POWERHOUSE PARRAMATTA

RESPONSE TO SUBMISSIONS REPORT

Powerhouse Parramatta

08 October 2020 | 2190947

Figure 3 Overlay of areas of archaeological potential with site works

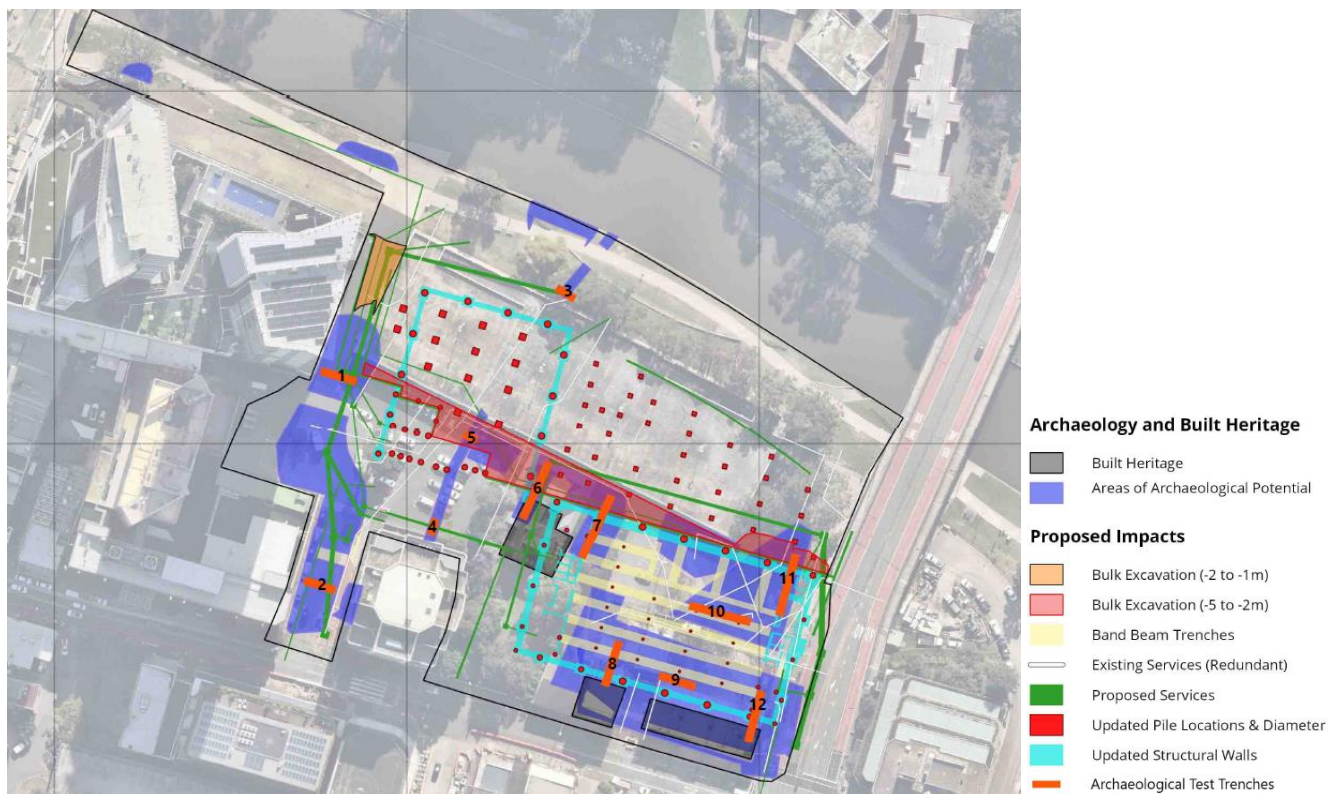
Curio Projects has prepared an Addendum Historical Archaeology Impact Assessment (HAIA) (**Appendix H**) and Addendum Aboriginal Cultural Heritage Assessment Report (ACHAR) (**Appendix I**) in response to the revised design and associated construction impacts which include the relocation of the plant, additional piles across the footprint of each building, the undercroft and service impacts. These addendum assessments address any potential impacts resulting from the amended ground works on historical and Aboriginal archaeological potential and provide a revised excavation methodology based on the new impacts.

The addendum HAIA further confirms that the site is assessed as having variable archaeological potential encompassing archaeological remains of both local and State significant research potential. Accordingly, 12 test trenches are recommended to investigate the nature and extent of the potential archaeological remains. Should the testing indicate the presence of intact and significant archaeological features and deposits, then it would be anticipated that the excavations would be expanded into open area excavations.

Additional areas of the site, including excavations for services lines, additional piling, landscaping and areas subject to impacts not identified in this report may be subject to archaeological monitoring and recording. The exposure of archaeological features or deposits identified by the Unexpected Finds Procedure may result in archaeological monitoring for specific areas of the site. Mitigation Measures CM-HER1 and CM-HER2 will apply.

Figure 7 Ferry's travel path intersecting with solar reflections above 500 Cd/m²

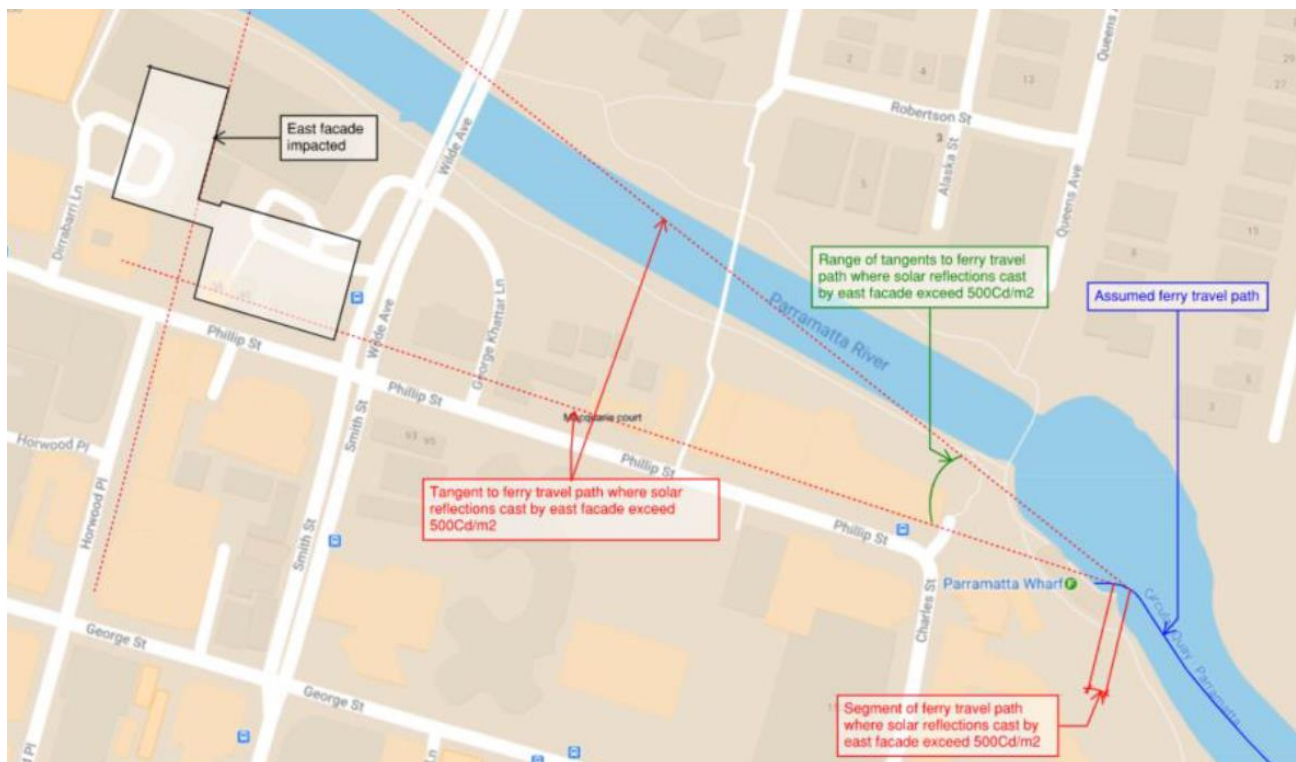
Arup has prepared an addendum Reflectivity Statement (**Appendix L**) which further analyses potential reflectivity impacts on ferry operations. The Statement notes that the impact of the façade's reflectivity on ferry operators stems from the east façades of the development when viewed from the river. This part of the development's façade casts solar reflections above the 500 Cd/m² threshold towards ferry operators, albeit for only a brief 8m travel path while the ferry turns to dock at the wharf (see **Figure 7** below).

Arup confirms that the reflections are not expected to result in unacceptable glare for ferry operators, and that the extent of reflection exposure in its context is minor. No further Mitigation Measures are recommended by Arup or proposed as part of this RTS.

Figure 8 Weekday coach layover locations

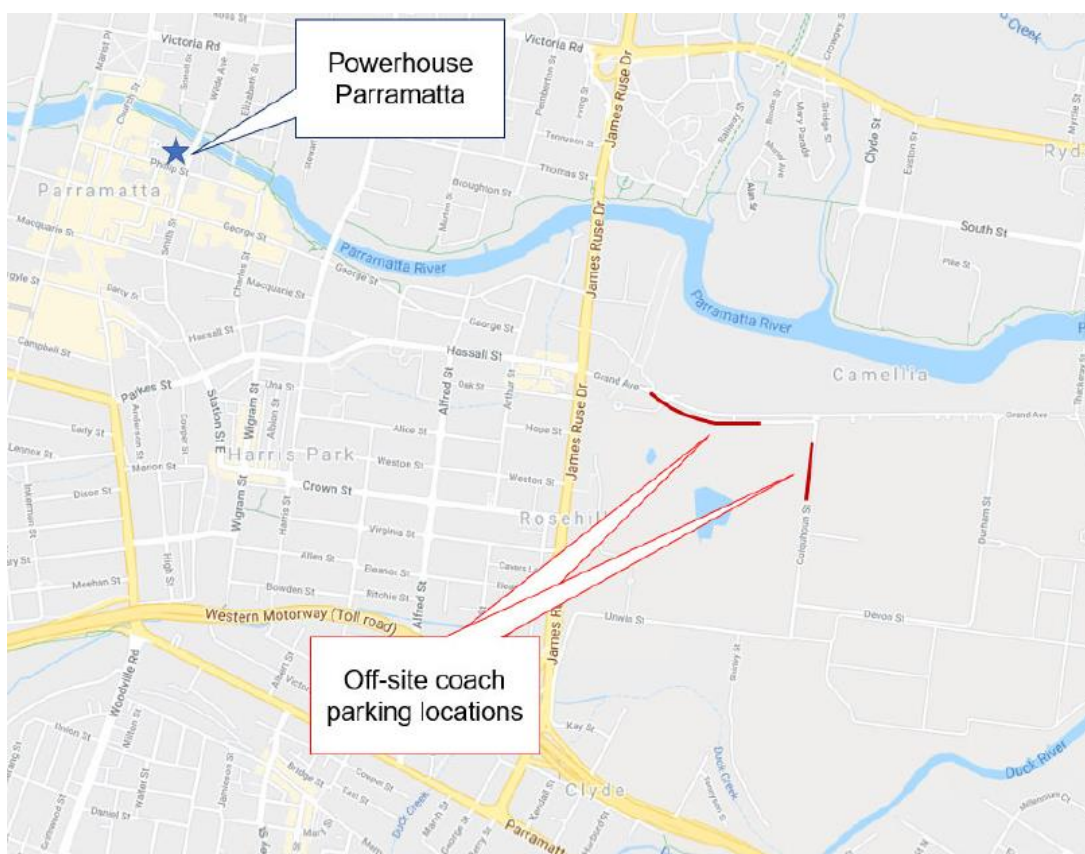
In response to the submissions received, the coach layover on Phillip Street has been reduced from three to two spaces allowing buses to park within an existing parking lane and enabling the removal of the indented bus bay. This coach passenger pick-up/drop-off area has been developed in close consultation with Powerhouse staff, taking into account the existing demand for coach parking at the Powerhouse Ultimo site as well as that likely to be generated at the future Powerhouse Parramatta. It should be noted that since the exhibition of the EIS, the NSW Government announced that the retention of the existing Powerhouse Ultimo site. This will have the effect of distributing demand for school groups across these two facilities in Sydney, rather than concentrating all demand at the future Powerhouse Parramatta.

Coaches can be diverted to find parking off-site in nearby designated areas before returning to Phillip Street to pick up passengers. Given the constraints for coach parking on weekdays in the Parramatta CBD, layover will occur within the Camelia precinct, in line with findings of the transport assessment as well as Council's response. Potential locations for coach parking will be Grand Avenue and Colquhoun Street (see **Figure 8** below).

Figure 9 Potential accessible parking and pickup and drop off facility

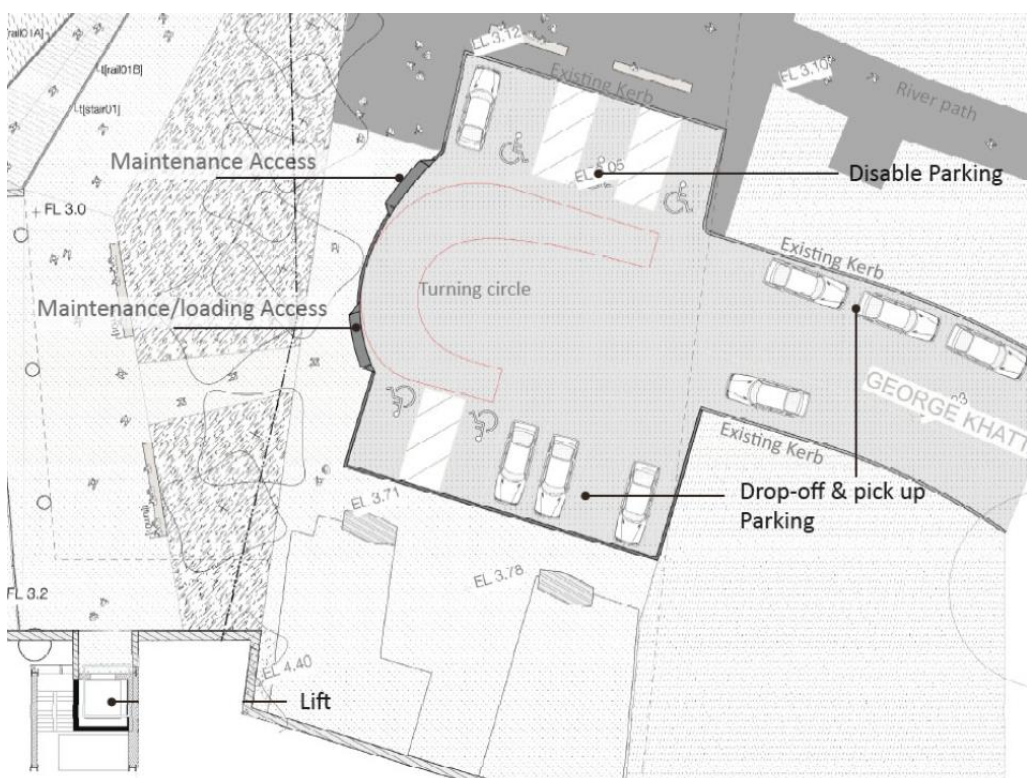
The updated Transport Assessment also includes a concept layout of the potential turnaround arrangements on George Khattar Lane (see **Figure 9** below) in response to Council's submission. This facility could accommodate accessible car parking as well as a drop off/pick up area to potentially service the Parramatta Powerhouse. These works may be conditioned to be completed as part of this project, or will be subject to future consultation with other agencies and may be completed via a separate planning process. A more detailed engineering plan will be provided to Council prior to the commencement of any construction, in accordance with Mitigation Measure D/O-TA3.
